**REZONING APPLICATION**

Zoning File No.           Z-0056-2023

**CITY OF GAHANNA, OHIO**  
**CRESCENT WOODS APARTMENTS**  
**CASTO COMMUNITIES**

# CONCEPTUAL MASTER PLAN

## Submitted Site Plan

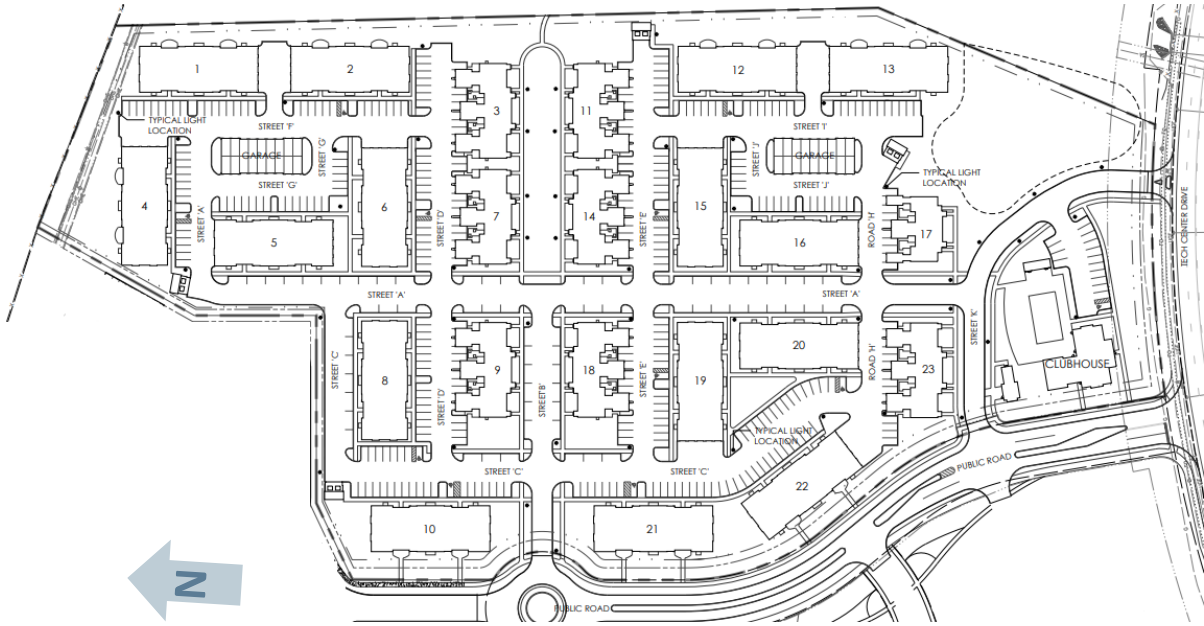
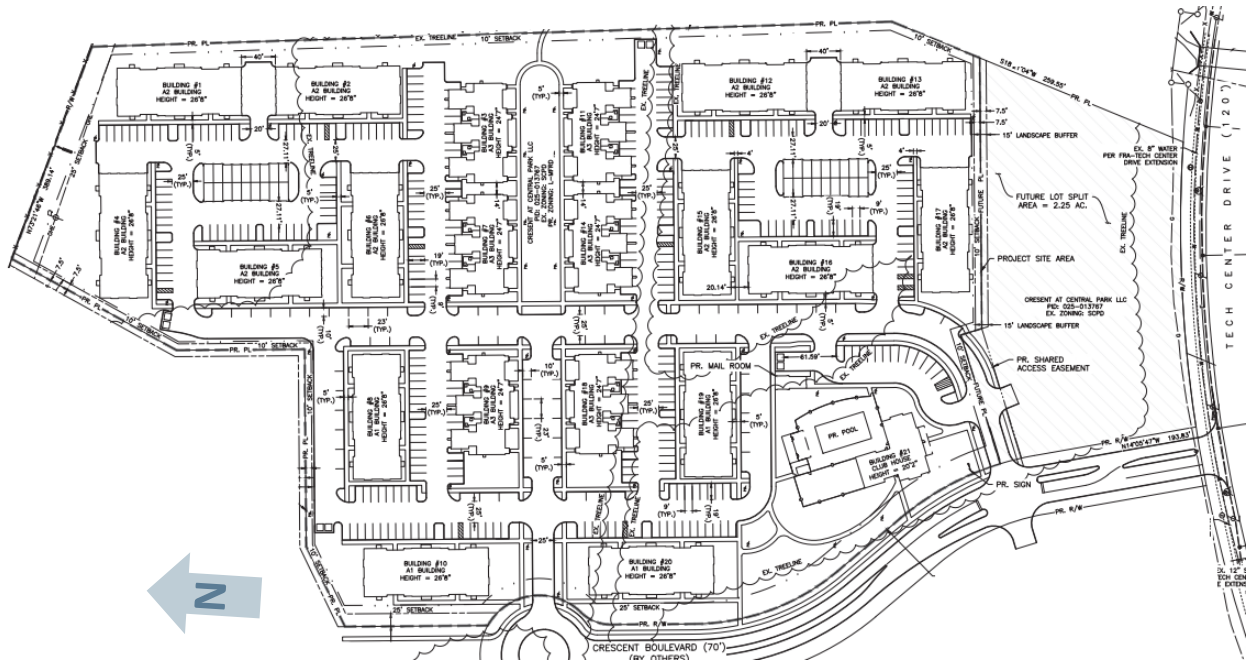
In 2021, Final Development Plan and Design Review applications for the project were approved by Planning Commission. At that point, the project's scope had been reduced due to City Council's input and contained 240 units, or 16.5 du/acre. Simultaneously, additional Variances for signage and screening requirements were approved. The current application contains many of the same Conditional Uses and Variances. Since the project's scope and boundaries have changed, most of these need to be reapproved by Planning Commission.

Staff recommends approval of the Final Development Plan, Variance, Conditional Use, and Rezoning as submitted. These four applications meet all applicable Code requirements and above criteria with the requested Variances. The requested Conditional Uses are necessary for higher density residential and have been recently applied to other multi-family developments. Additionally, the Land Use Plan identifies a need for more diverse housing options in the City as the region continues to grow. All of the requested Variances are either minor in nature, necessary to meet other Code requirements, and/or have been previously approved for this site.
